RECORD OF TECHNICAL CHANGE

Technical Change No. 2

Project/Job Name CAU 424 CAIP

Changes to the *Corrective Action Investigation Plan for CAU No. 424: Area 3 Landfill Complex, Tonopah Test Range, Nevada, Rev. 0; DOE/NV-476*.

Figure 4-2
Schematic of the Core-Barrel Sampler

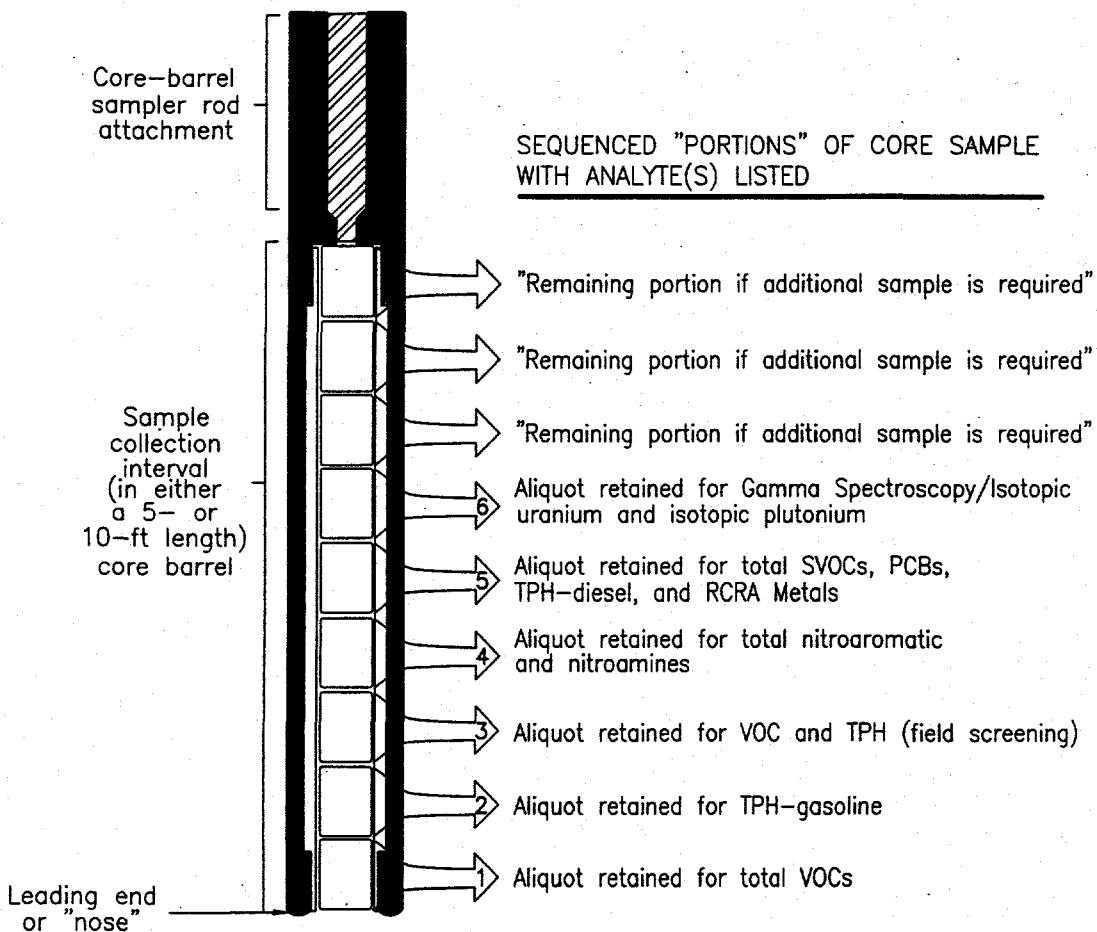
Page 37, Fig. 4-2: Delete reference to nitroaromatic and nitroamine analyses for portion 4. These will not be done, inclusion was a mistake. The fourth portion of the core will be retained for the analyses formerly assigned to the fifth portion, etc.

Page 37, Fig. 4-2: Insert "total pesticides" in association with PCBs (total pesticides/PCBs) for the aliquot 5 allotment, per Table 3-1, to correct the statement.

Page 37, Fig. 4-2: Correction - The core-barrel sampler does not have a rod attachment section. The sample collection interval is the bottom 2-ft of every 5-ft interval. This is consistent with the revised text.

Page 37, Fig. 4-2: The remaining soil above portion 3 will be homogenized before being allocated to aliquots for the remaining analyses. Homogenization was mistakenly omitted in the text, and this figure consequently showed distinct portions of the core allocated to the other analyses.
